## OFFICIAL NOTICE OF DECISION

**Project# 1010181**

RE: Project #1010181, PNM Richmond Switching Station  
Site Development Plan for Building Permit

RE: DRB Comment Responses – Project #1010181 – Richmond Switching Station

**PNM PUBLIC SERVICE COMPANY**  
 OF NEW MEXICO  
 SITE DEVELOPMENT PLAN FOR  
 BUILDING PERMIT  
 PNM - RICHMOND SWITCHING STATION  
 V.4

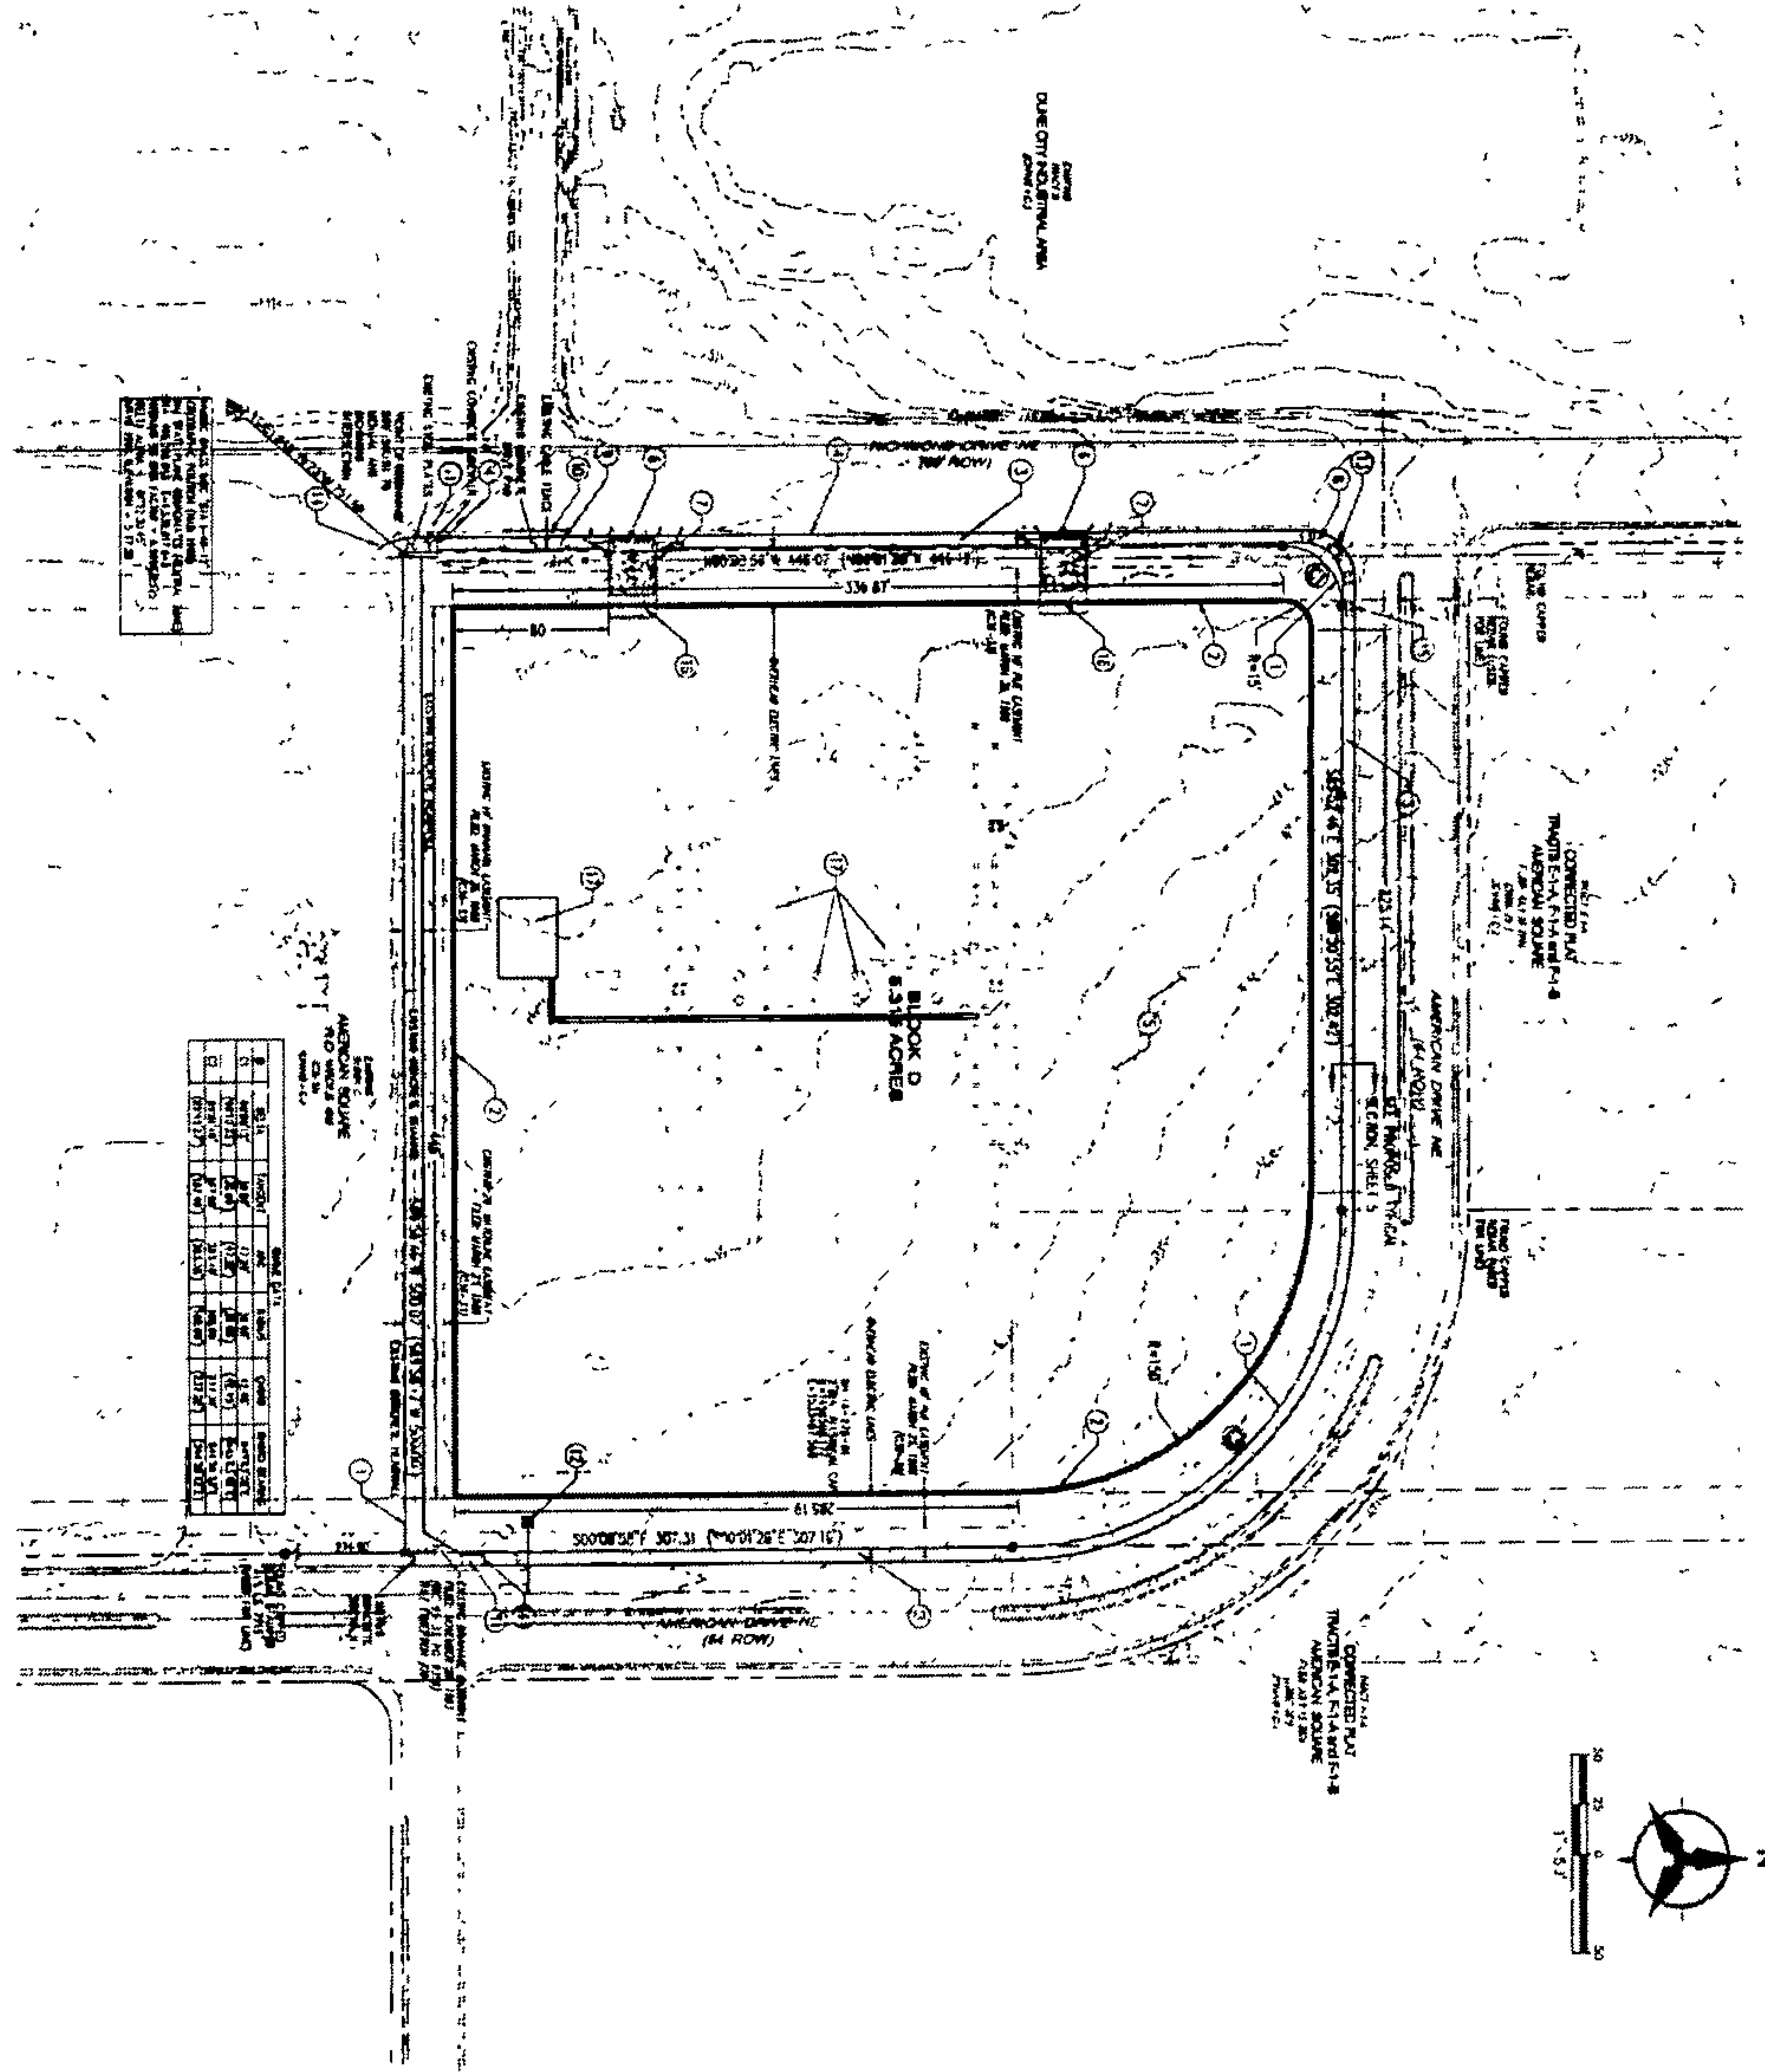
1. Sheet 1: Please re-instate keyed note 17, both the written note and the two instances where it is used to label equipment inside the switching station wall.

*Keyed Note 17 and the two instances where it is identified on the plan have been reinstated.*

PNM PUBLIC SERVICE COMPANY OF NEW MEXICO		
ELEVATION VIEW		
115kV LAYOUT		
RICHMOND SWITCHING STATION		
DR: LK	TR:	DATE: 10/01/14
CKD:	OK:	SCALE: 1/2" = 1'-0"
APP:	ACAD FILE: scs347	SHEET 5 OF 6
REV. NO:

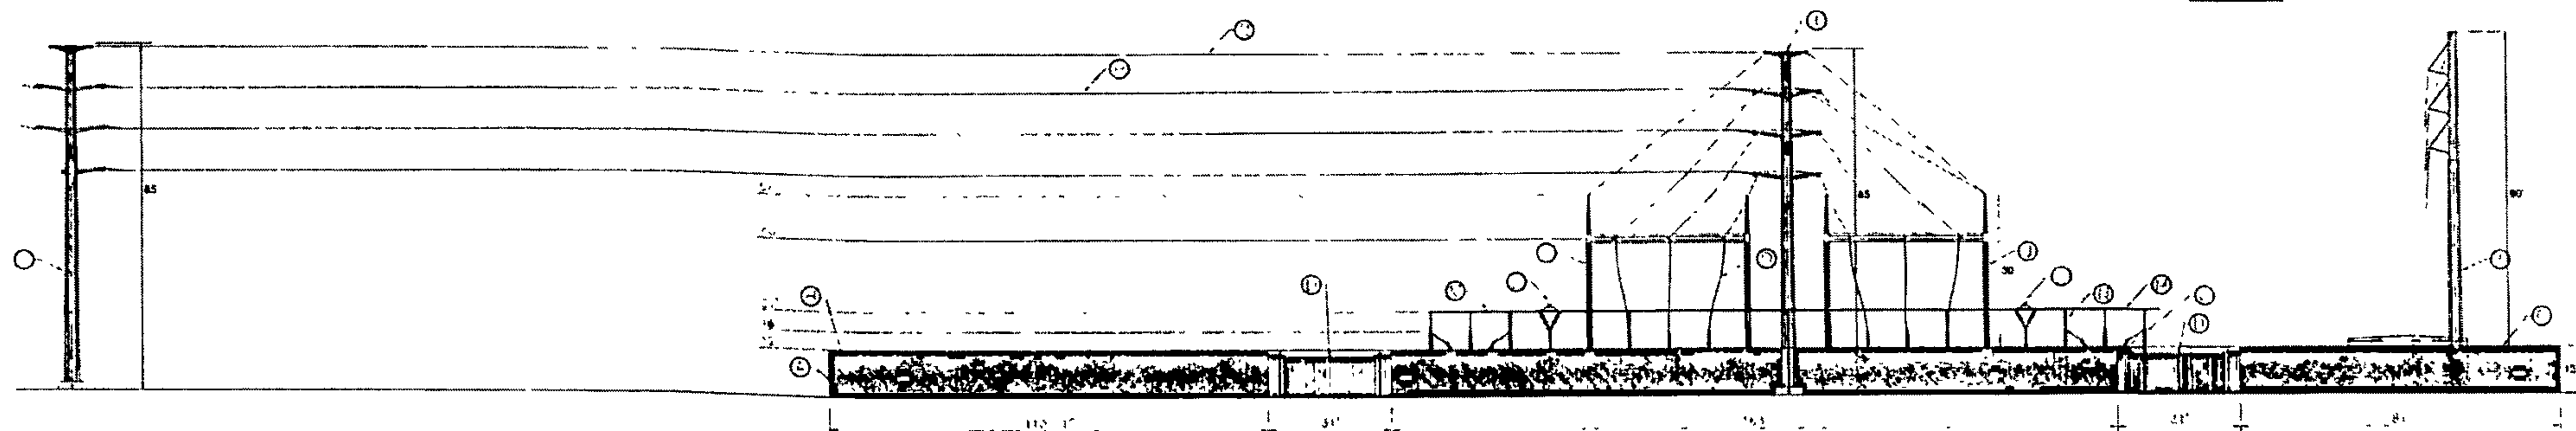
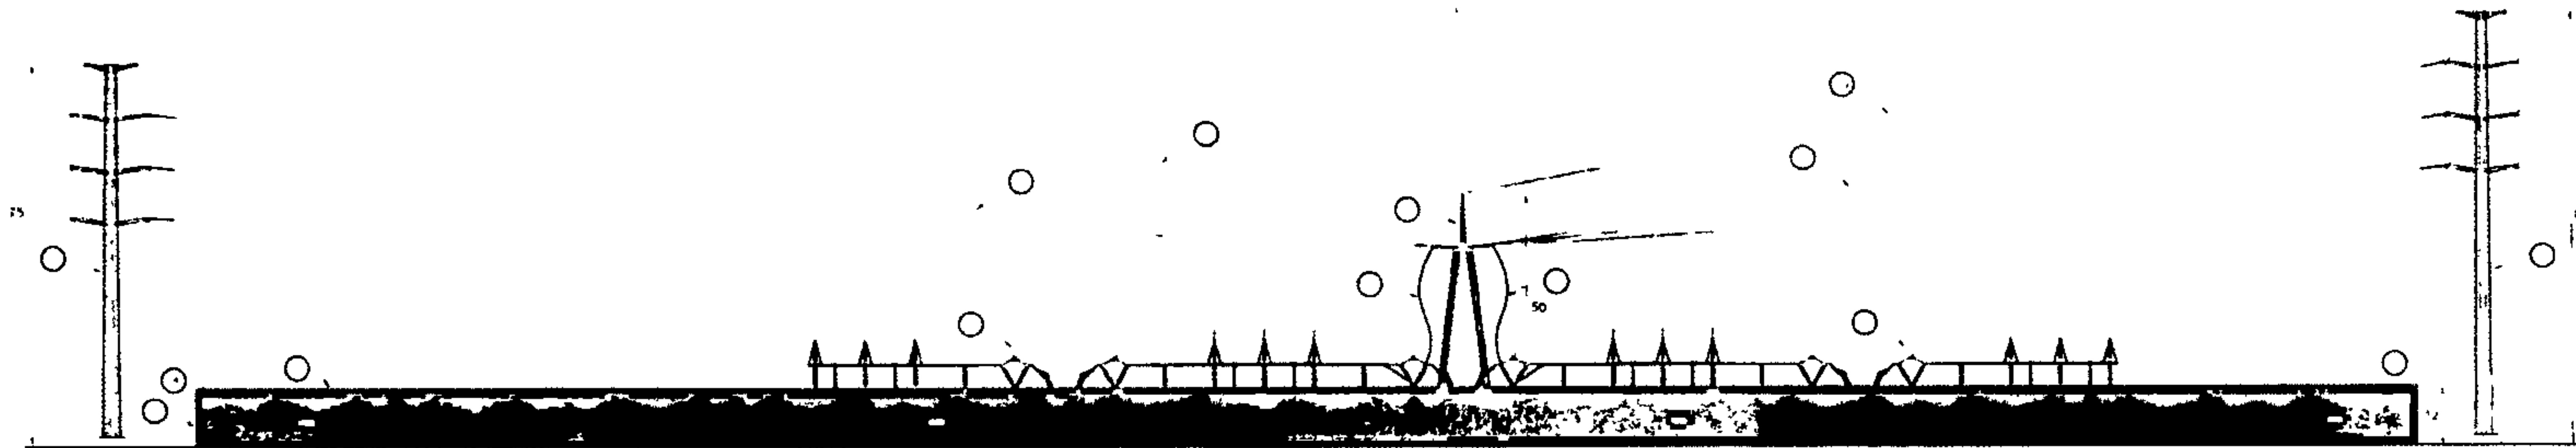
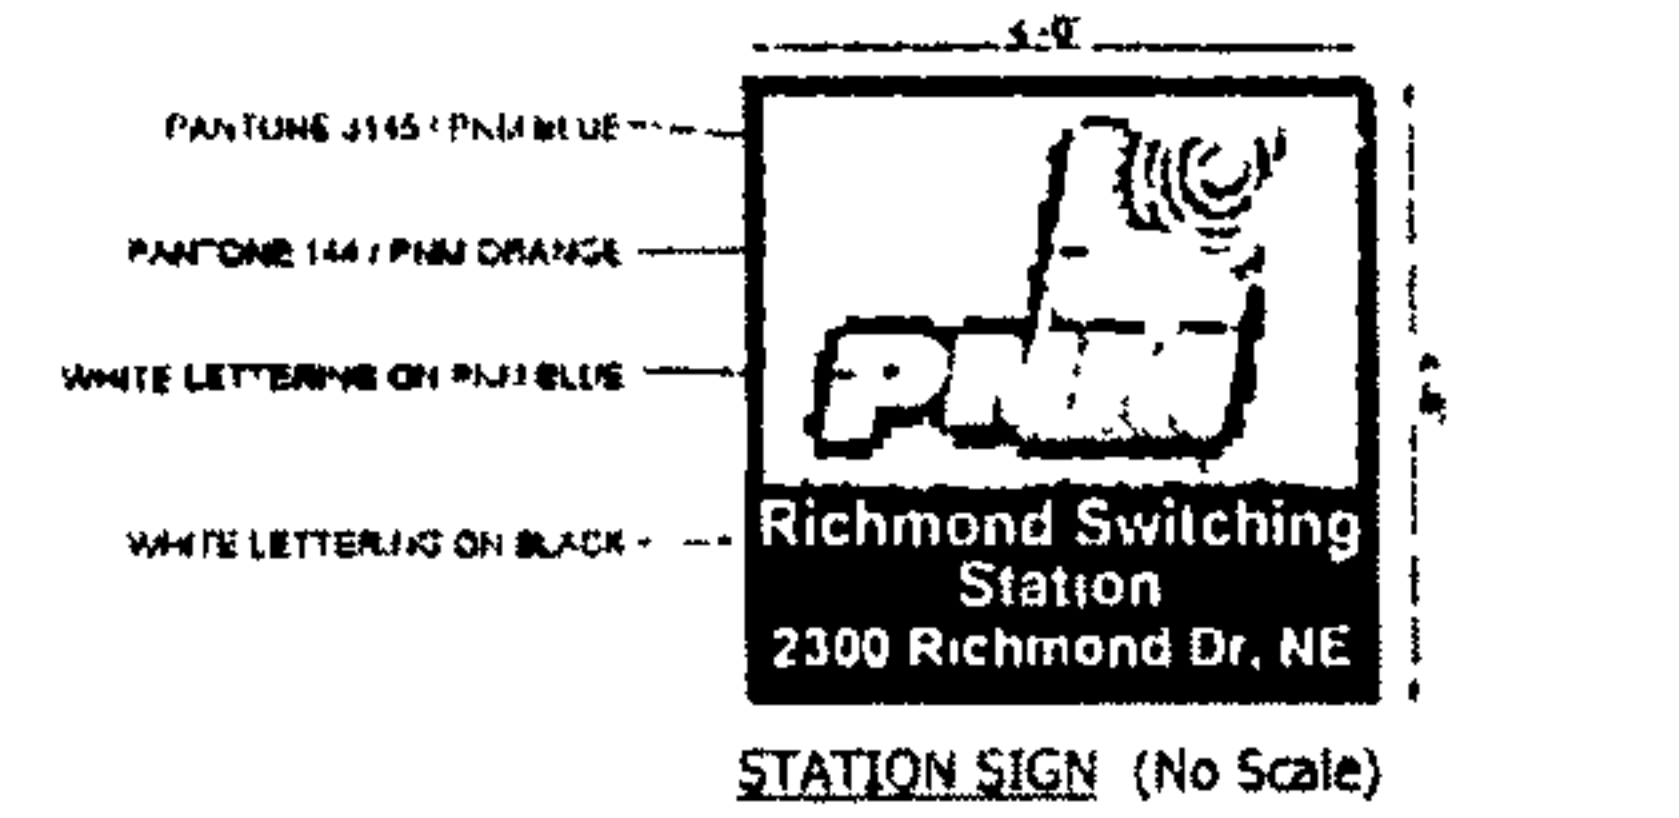
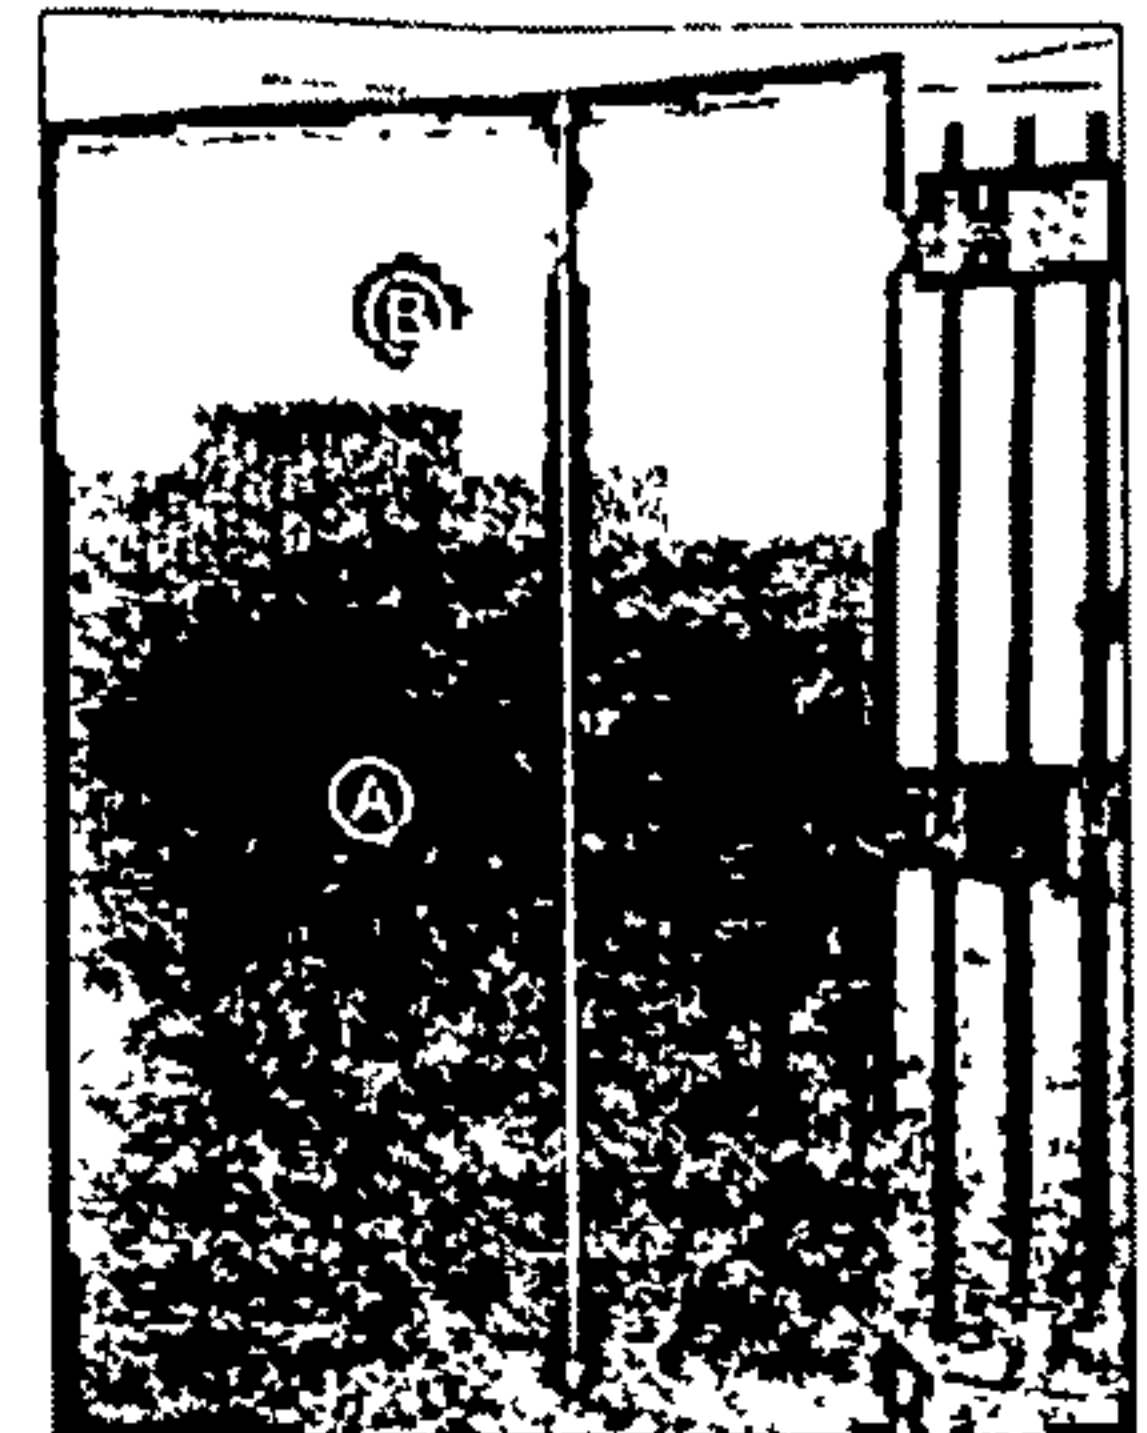
- A. A note shall be added to state that the switching station will comply with NEMA noise guidelines (Design Standard #11).
- B. A note shall be added to state that the switching station will be maintained graffiti free (Design Standard #15).

- A wall detail, in elevation view, shall be added to the detail sheet and specify dimensions, material(s) and colors.
- The split-faced and smooth-faced block shall be noted as different colors so they match the color rendering.
- The continuous wall cap shall protrude a minimum of 2 inches [ref: §14-16-3-19(C)(2)(b)(1)(d)]. *Note correct reference cited.*

*The following notes have been added on V.3 on Sheet 5 of 6 and Sheet 6 of 6:*

- A wall detail has been added to V.3 Sheet 5 of 6 and Sheet 6 of 6 specifying wall dimensions, materials and colors.*
- Photos of Pecos Gold #250 split-face and smooth-face block have been added to V.3 Sheet 5 of 6 and Sheet 6 of 6. A note has been added to V.3 Sheet 5 of 6 and Sheet 6 of 6 that states, "SMOOTH-FACE READS AS LIGHTER COLOR."*
- A note has been added to V.3 Sheet 5 of 6 and Sheet 6 of 6 that states, "CONTINUOUS WALL CAP SHALL PROTRUDE TWO INCHES."*
